## PLANNING REPORT

**6. Leo Alfred Jewelers**

**4115 West Dublin-Granville Road  
Final Development Plan  
Corridor Development District**

Case Number: 07-018FDP/CDD  
Request: To consider a 5,495-square-foot retail space with associated parking and landscaping; for property located on the south side of Sharp Lane and west side of Shamrock Boulevard within the Shamrock Crossing Planned Unit District.  
Procedure: Review and approval of a Final Development Plan under the PD provisions of Code Section 153.050 and modifications under the Corridor Development District under the provisions of Code Section 153.115.  
Applicant: Leo Alfred Jewelers, Thomas Laudick; represented by Chad Flowers, Bird Houk Collaborative.  
Planning Contact: Jennifer M. Rauch, AICP, Planner.

# PROPOSED ELEVATIONS

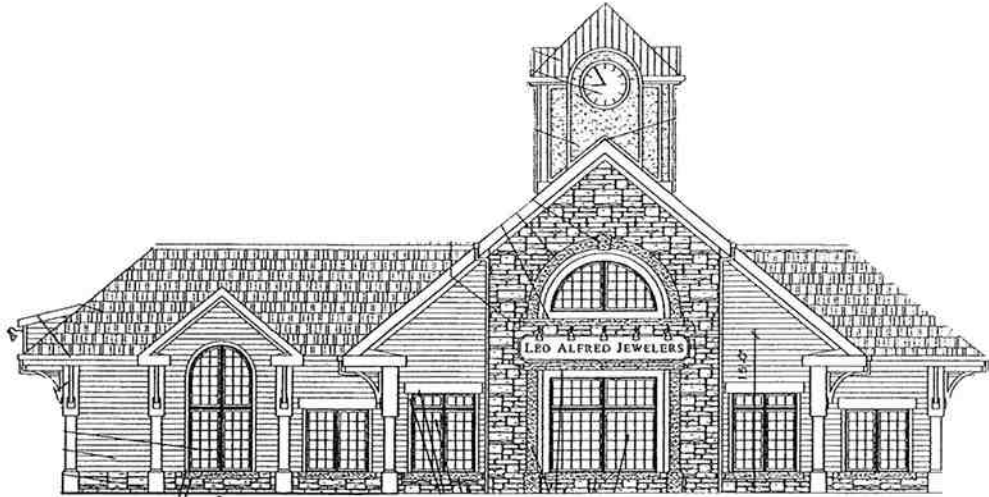
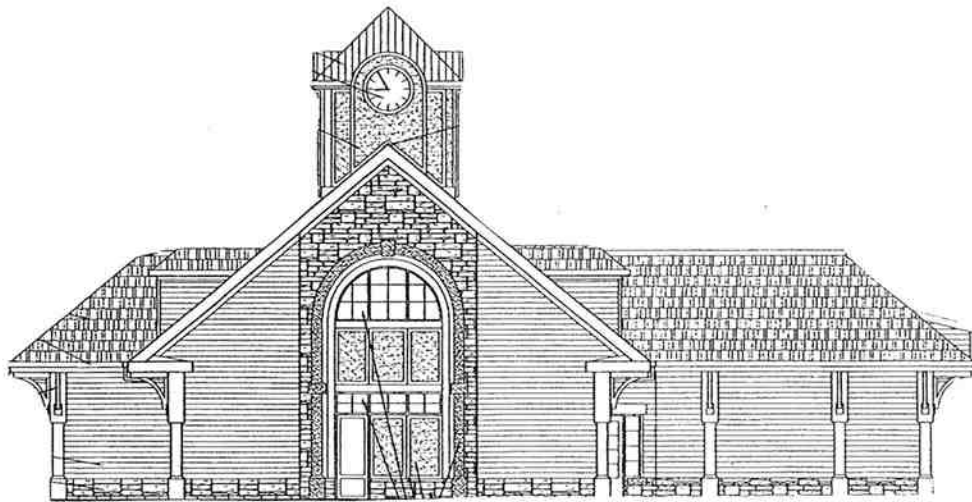
*Architecture.* The approved text requires four-sided architectural design is coordinated with the architectural style for the district. The proposed building is similar to what was presented at the preliminary development plan and incorporates large arched window surrounded by stone on the north and south elevations. The building incorporates wood pilasters to support the roof overhang, which is a prominent feature on the east and west elevations. The most prominent architectural feature is the proposed clock tower located on the north elevation, which incorporates a real time clock and red standing seam roof. The overall design utilizes quality materials and a high level of fenestration.

*Building Height.* The text requires that the maximum building height not exceed 35 feet. While the main building meets this requirement the clock tower is shown at 41 feet. Planning has considered this as an architectural feature, and a non-habitable space. The Code typically measures height to the main roof line.

*Building Material.* The approved building materials include brick, stone/synthetic stone, cedar siding and trim, stucco/synthetic stucco, and engineered wood composite material. The proposed building is constructed of Hardiplank siding (*Sherwin Williams, Divine White*) with stained wood brackets and pilasters details located along the four façades of the building. A limestone water table and stone accent walls are also used along the exterior of the building. The proposed materials for the clock tower include cementitious panels, painted to match the building. The building roof construction will be slate (*Carlisle Ecostar, Midnight Grey Blend*), while the roof material for the clock tower is standing seam (*Colonial Red*).

# PROPOSED SIGNS

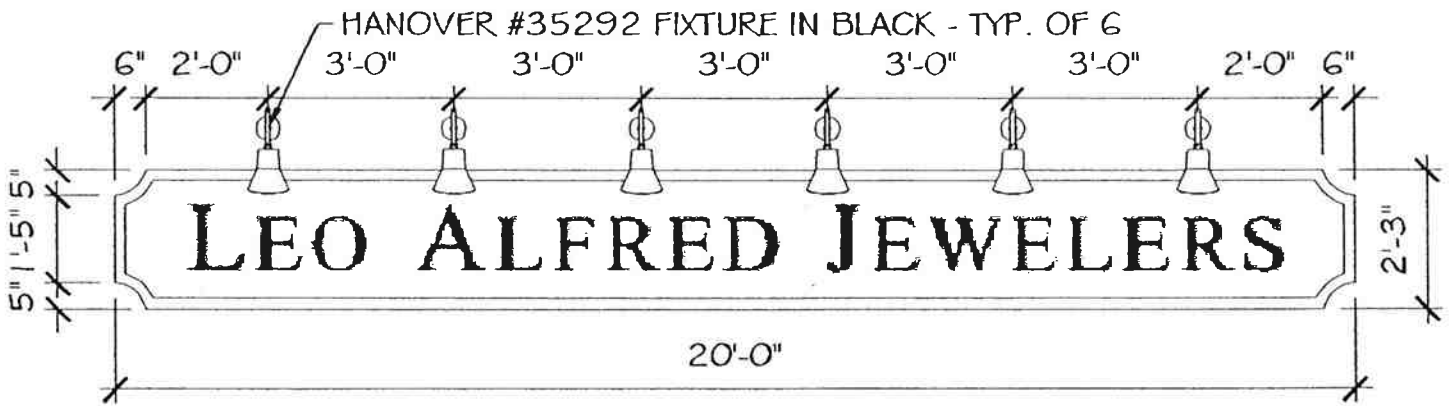
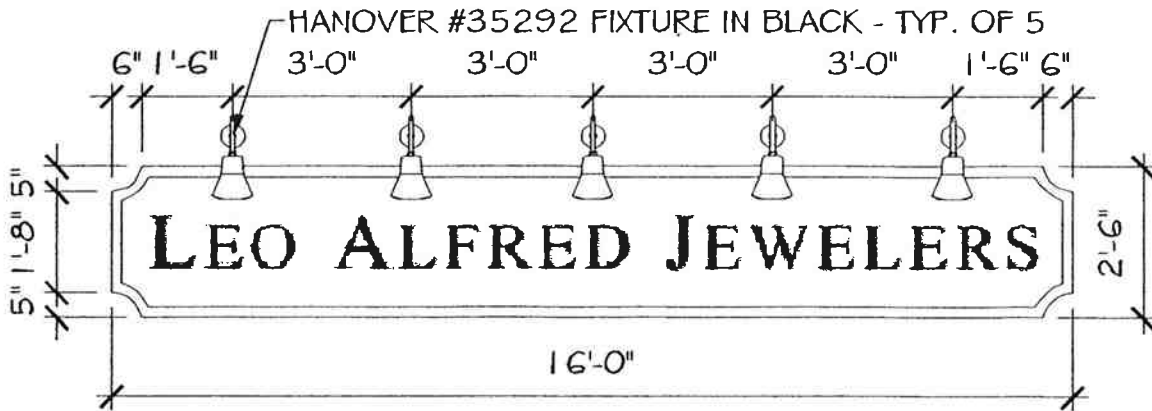
*Proposed Signs.* The approved sign package permits either one ground-mounted sign or wall signs on each public street frontage. The maximum square footage for wall signs facing a public street is 40-square-feet with the maximum permitted height of 15 feet to the top of the sign. The applicant has requested two wall signs; a 45-square foot sign on the north elevation facing Sharp Lane and a 40-square-foot sign of the east elevation facing Shamrock Boulevard. Each sign is rectangular in shape with three-inch radius quarter-round cutouts at the corners. The proposed sign panel will be dark green with individual gold letters. One of the proposed wall signs exceed the maximum square footage outlined in the text. The proposed signs are integrated into the building façades and complement the architectural character of the building.

**Criteria not met:** One wall sign fails to meet the requirement of the text. Apart from this, the proposed signs are architecturally integrated into the design of the building and are consistent with the high quality design found within adjacent developments.

- 1) That the applicant may reduce their parking spaces requirement by four spaces. If this were not approved, the spaces could be added at the two southerly rows of parking (two spaces for each row).
- 2) That the 45 foot wall sign be permitted. If this were not approved the wall sign must be reduced in area to 40 square feet.
